PLAN COMMISSION STAFF REPORT

Tuesday, November 12, 2019 – 6:00 p.m.

New Site Plan

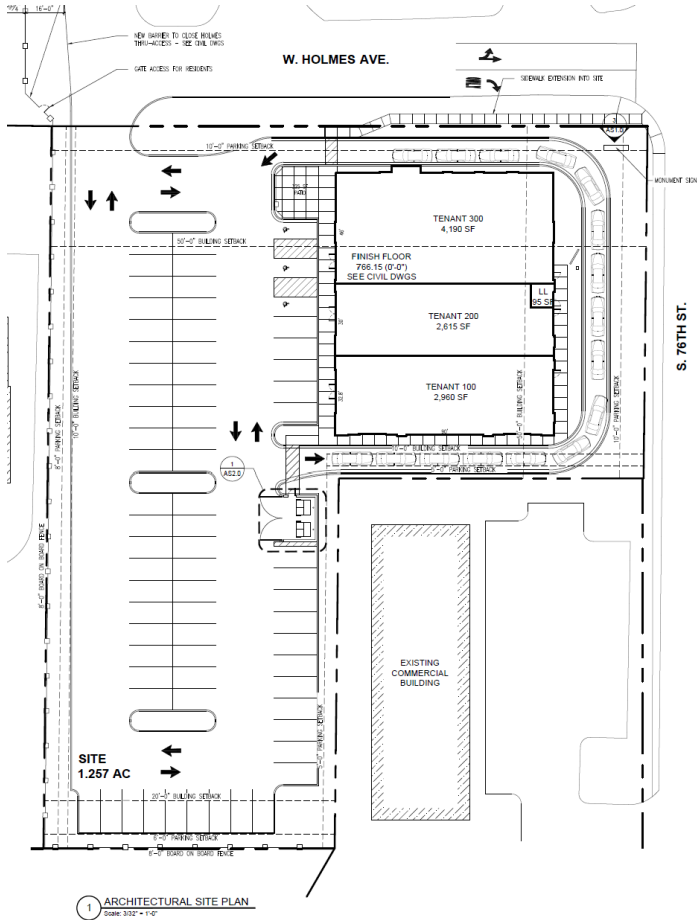
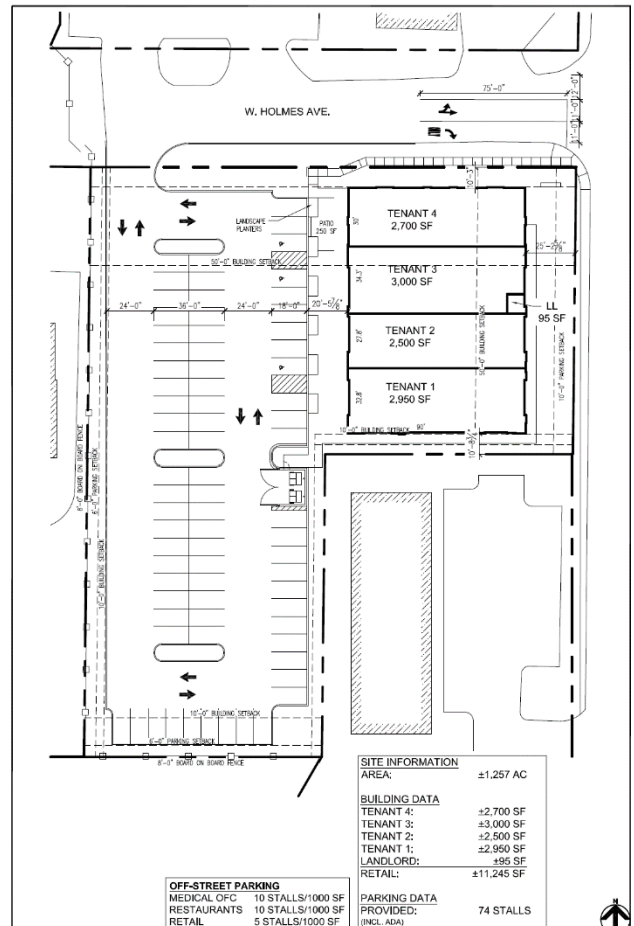
As mentioned above, the amended site plan eliminates the drive-thru component, which would have started on the south side of the building, wrapped around the east, and vehicles were to exit on the north side of the building. With the elimination of the drive-thru, the developer has increased the size of the building:

Staff had recommended to the developer to modify the location of the site entrance/driveway cut, shifting it east, in line with the eastern parking lot drive aisle, and to also move the refuse enclosure location. The driveway entrance shifting would possibly allow for more green space at the northwest corner of the site for snow storage. The architect and engineers said that these two (2) recommended changes would not be feasible with the grading.

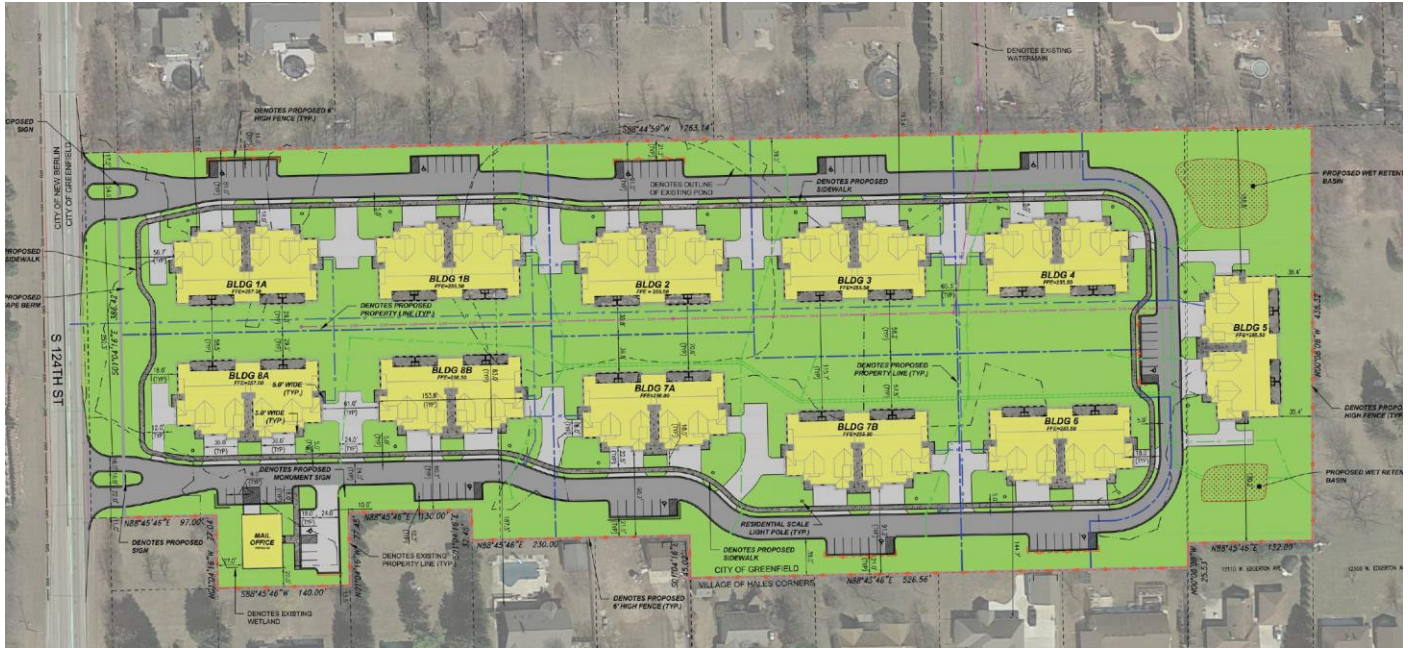
The side elevations include a vertical panel in between the windows. Staff would like to see this panel feature removed as it seems out of place and doesn't match the other building materials/design. Staff recommends that the upper portion of the buildings utilize a shake siding to add an architectural variation to the horizontal siding. The shake siding should be a different color tone than the horizontal siding, again adding visual variation to the building without adding a substantial price increase. In addition, staff recommends some architectural accents to the building, such as keystones above the windows and/or craftsman-style gable accents, similar to the picture examples provided on this page.

The interior facades facing the courtyard will include large windows on the first and second floor. The entire interior courtyard facades are proposed to be constructed of horizontal siding. Staff recommends that the vertical columns, dividing units, utilize a stone veneer. In addition, staff recommends that the patio walls be constructed of an alternative material other than siding, such as glass. Small shed-roof dormers project from the half-story above the second floor. A private 10' x 19' patio/veranda with a built-in vented gas grill designed for year-round outdoor enjoyment is also present. The developer needs to check that gas grills are allowed per Code, as the building inspector suggested electric grills only would be allowed. This outdoor amenity is covered on three sides and roofed to allow enhanced privacy and to comfortably experience the outdoors even during inclement weather.

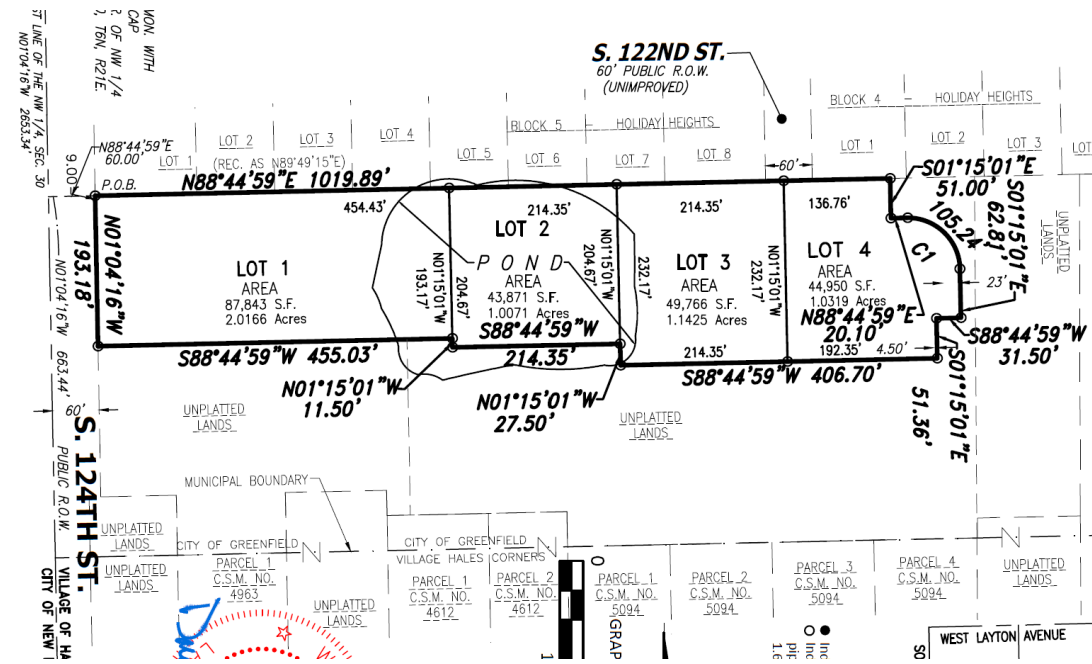
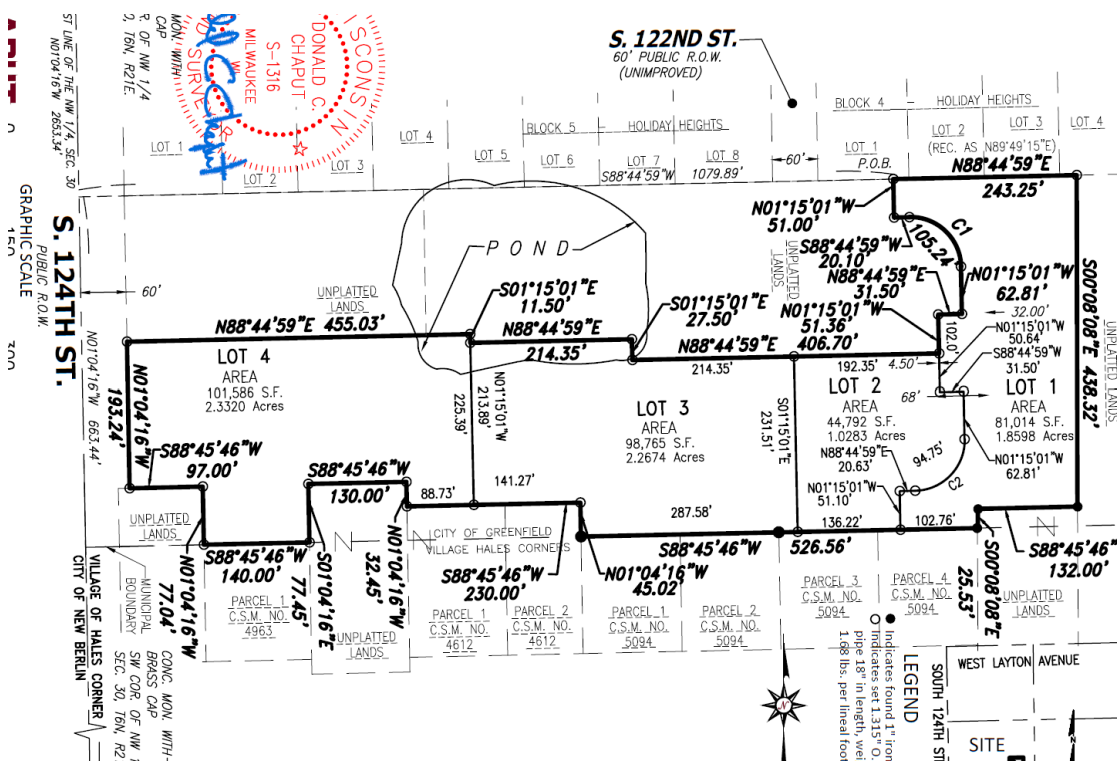
The development would have two (2) entrances on S. 124 St. and would be serviced by a private U-shaped drive with a poured curb. Staff recommends acceleration/deceleration lanes on S. 124 St. be provided at the site entrances. A private walkway will circle the development along the private drive.

The developer reduced the number of surface stalls by 43 since the conceptual plan. The site plan still shows an overabundance of 154 provided parking spaces. Staff continues to recommend a reduction in the number of off-street parking to more closely align with the parking standards in the Code.
